The Following changes in the tender documents are effective immediately. This addendum will form part of the Contract documents.

Inquires during the solicitation period

SOUTH-EAST TOWER

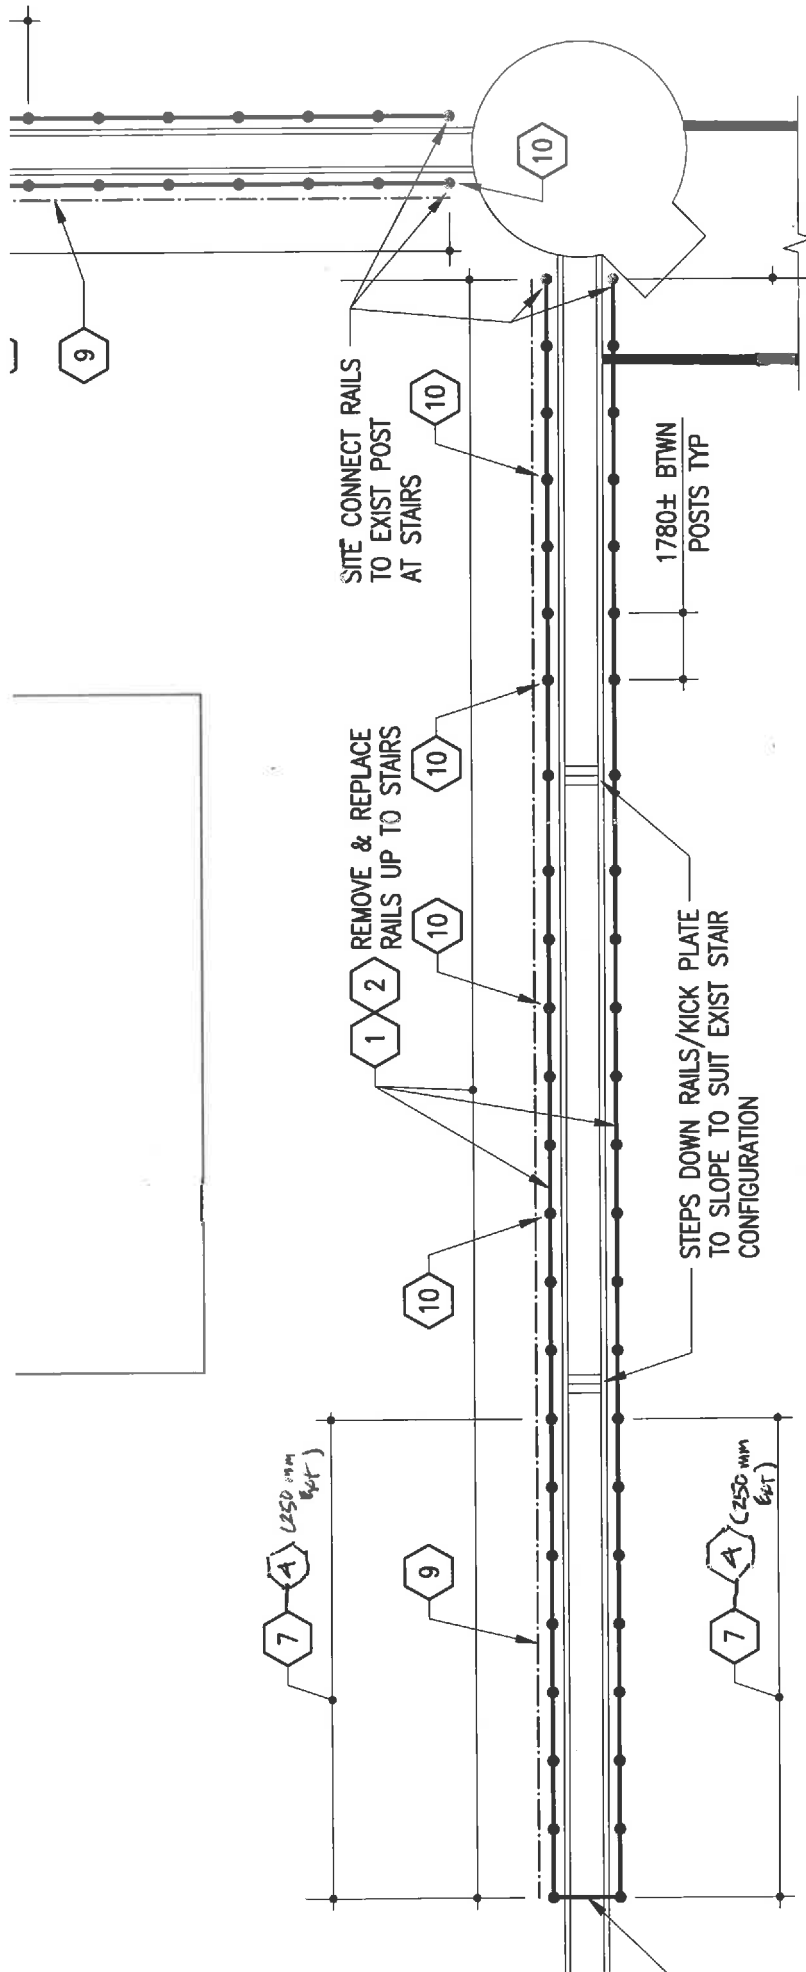
11	Detail C and F below show plates for repair, can we have the detail of these plates as some of the existing railings has cross tee, if we removed the railings as per detail C, the fittings will not make the connection flushed with the new pipe member? For detail F, if we removed the damaged post, there will be a gap between the new post (without fittings as this will be welded connection).	Plates only shown diagrammatically for installation if necessary – connection is to be detailed by supplier with shop drawings for review.
12	See detail below clouded part, if the railings will be replaced as per detail 1 & 2, what will be the note 8, to replace damaged post?	See response to Item #1 and attached sketch
